Town of Pittsford Design Review & Historic Preservation Board

AGENDA

April 11, 2024

Town of Pittsford Design Review & Historic Preservation Board
MINUTES
March 28, 2024

2 SECOND FLOOR PLAN
SCALE: 1/4" = 1'-0"

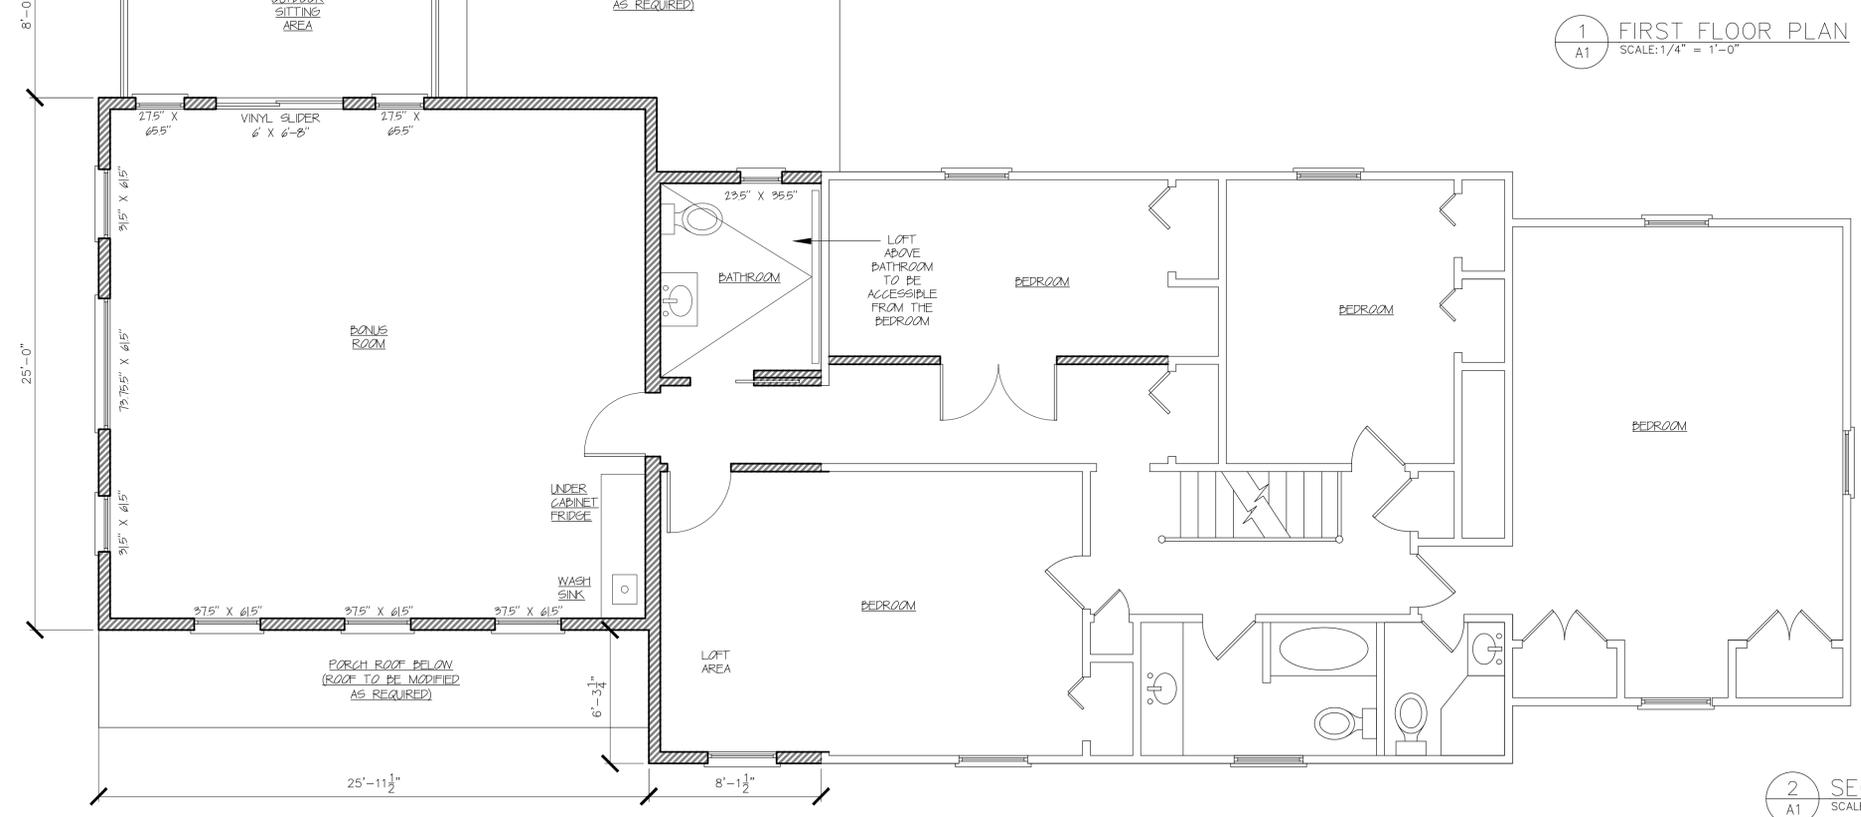
Town Attorney Robert Koegel stated that the current plans before the Board are not in compliance with the Zoning Code due to the creation of a secondary dwelling unit within the interior plans. He urged the Board to only make comments on the design and wait for zoning compliance before making any motions. Mr. Koegel gave an overview of the term "dwelling unit" as defined in Town Code §185-8 and noted the area of concern on the submitted plans.

SHEET TITLE
ELEVATIONS

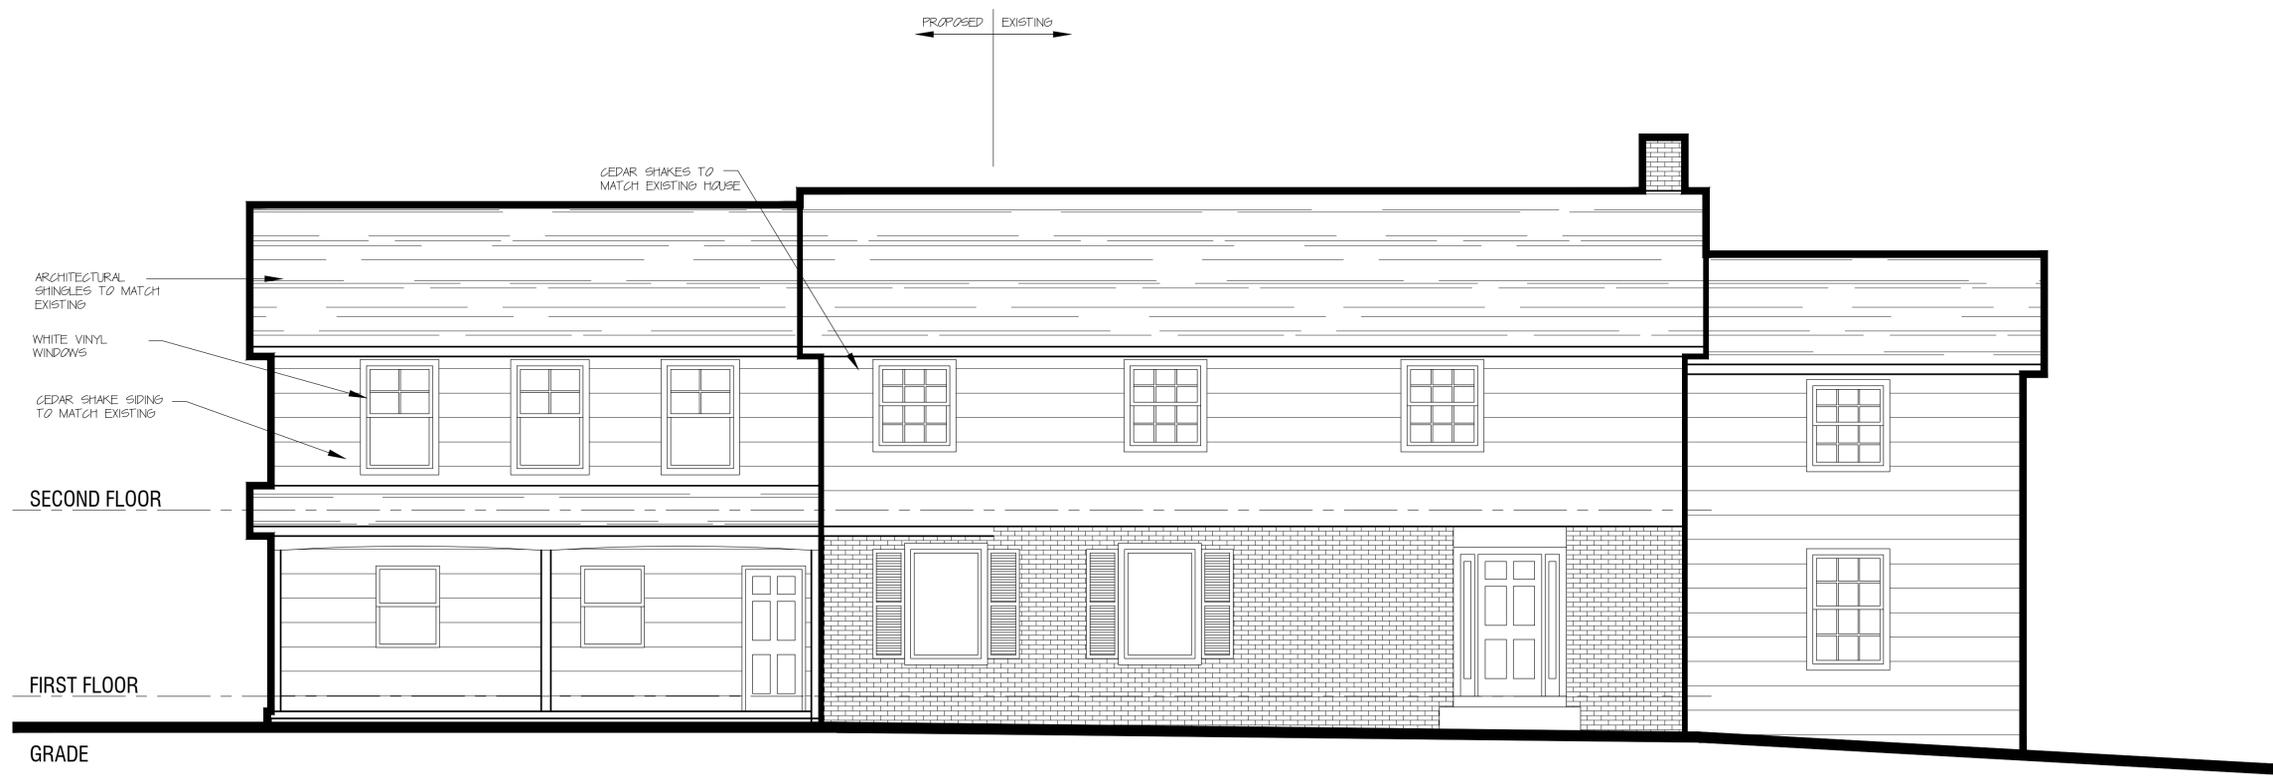
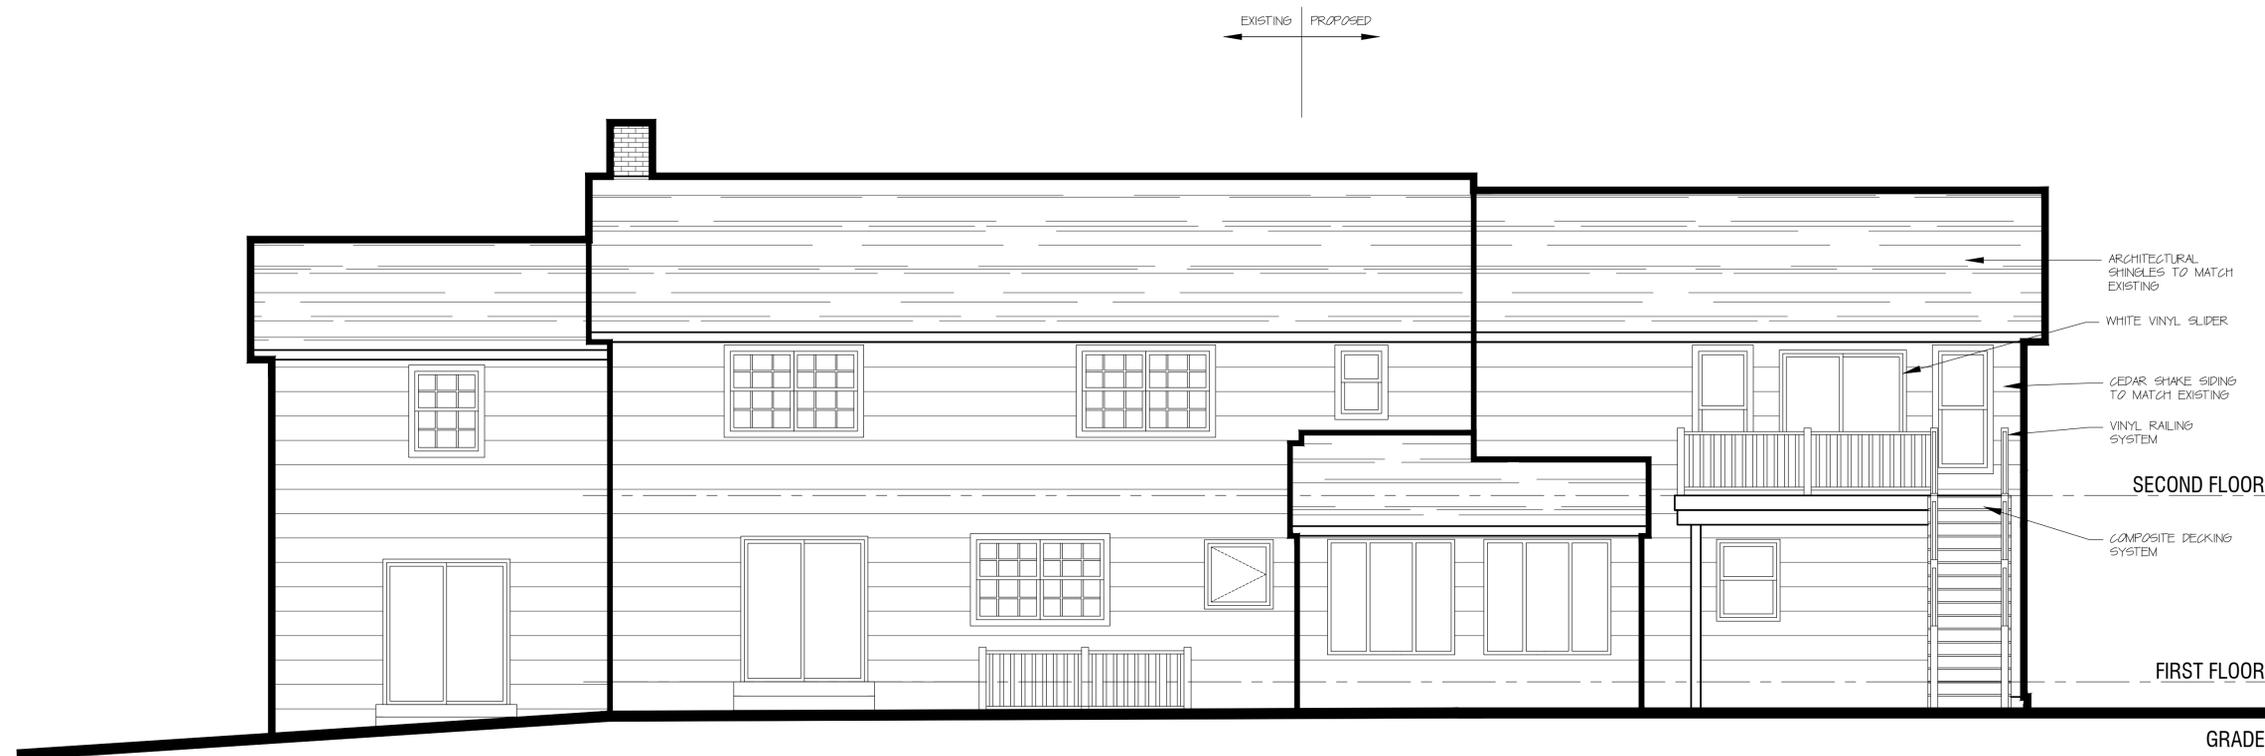
Chairman Schneider asked the Board if they had any questions or concerns on the exterior design. Board Member Salem stated the board and batten siding does not seem very compatible with the look of the home and adds a third texture. Ms. Polidor stated that the cedar shake is much more expensive but that she could concede to using it if the Board preferred it. Chairman Schneider asked a few questions about the windows, and Ms. Polidor stated that the intent was to blend and harmonize the different window designs that already exist within the home. Chairman Schneider stated that the windows over the garage are appropriate, though, if

possible, it would be better to match the current upper windows. Ms. Polidor stated that she already has them and would prefer to be able to use them.

Chairman Schneider stated that it would better suit the home to have the peak of the south elevation follow the same lines and pattern as the rest of the home. There was further discussion about the ridgeline, chimney, and windows.

1. As to the design of the west elevation, the cantilever on the middle part of the second floor should align with the current structure rather than step back towards the addition.
2. As to the siding of the addition, the siding should match the existing structure rather than introduce a new material.
3. As to the bonus room addition, the window proportions and double-hung sliding windows that are proposed would be acceptable because the addition is a new structure, though they are not preferred. The picture window is acceptable.
4. As to the addition in its entirety, the massing is suitable for the home.

The Design Review & Historic Preservation Board has asked the applicant to return to the Board with a finalized design once zoning code has been met.
